**DIVISION OF RATEPAYER ADVOCATES  
CALIFORNIA PUBLIC UTILITIES COMMISSION**

**Testimony on  
Application of Pacific Gas and Electric Company for  
Compliance Review of Utility Owned Generation  
Operations, Electric Energy Resource Recovery Account  
Entries, Contract Administration, Economic Dispatch of  
Electric Resources, Utility Retained Generation Fuel  
Procurement, and Other Activities for the Period  
January 1 through December 31, 2012 (U39E)**

**A.13-02-023**

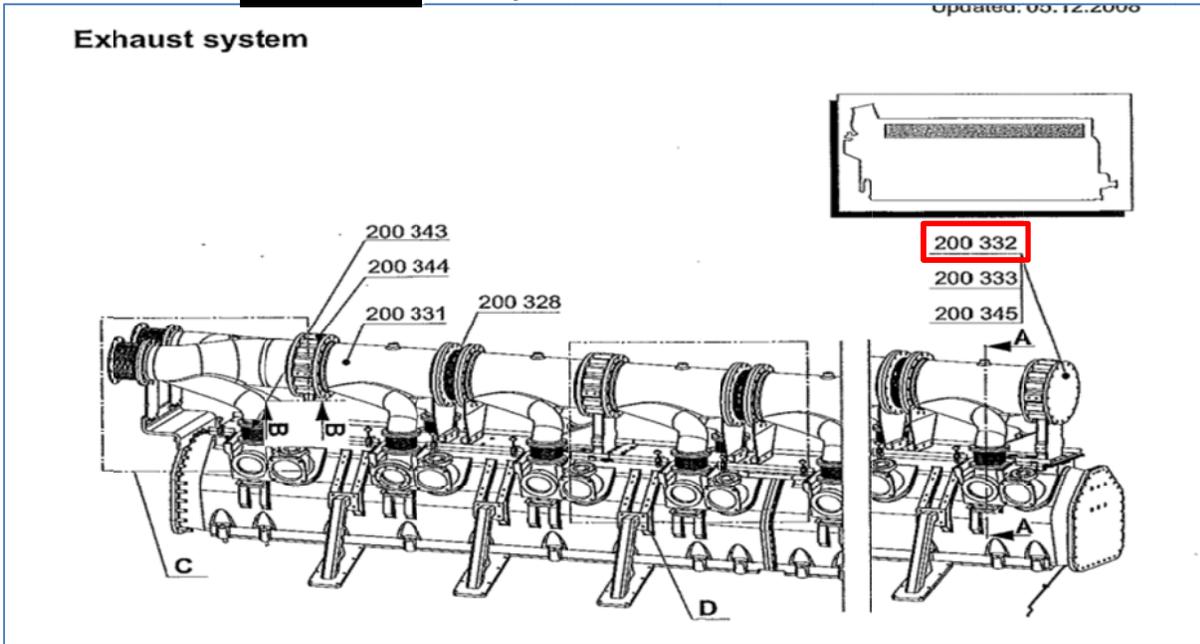
13  
14                   To further understand how this damage occurred, DRA organized a conference  
15 call with PG&E on July 31, 2013. In preparation for this conference call, PG&E's  
16 witness provided (non-confidential) diagrams of the exterior of the HBGS engine exhaust  
17 system, shown below as figures 3.1 and 3.2, and one picture of the interior, shown below  
18 as figure 3.3. According to PG&E's witness, the component numbered 200 332 (shown  
19 in both figures 3.1 and 3.2 in red box) is the exhaust bellows expansion joint, and its  
20 function is to support the structure of the exhaust manifold from the extreme conditions  
21 created by the flow of heated gas used in each engine.

4 **Figure 3.2: Expansion of HBGS Engine**  
 5 **(from PG&E's e 1<sup>st</sup> July, 2013)**

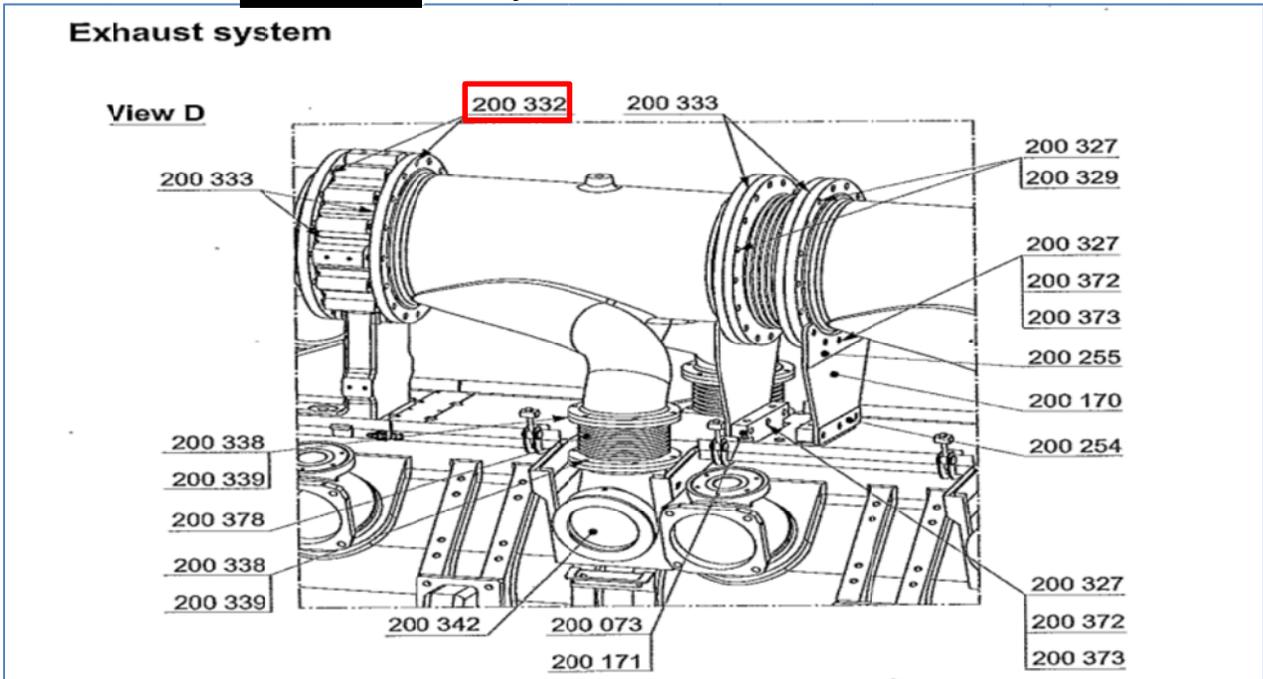
1 [REDACTED]<sup>55</sup> Figure 3 depicts an  
2 example where the [REDACTED].  
3 According to PG&E, [REDACTED]  
4 [REDACTED]  
5 [REDACTED]<sup>56</sup> The turbocharger is located close to the exhaust gas manifold.
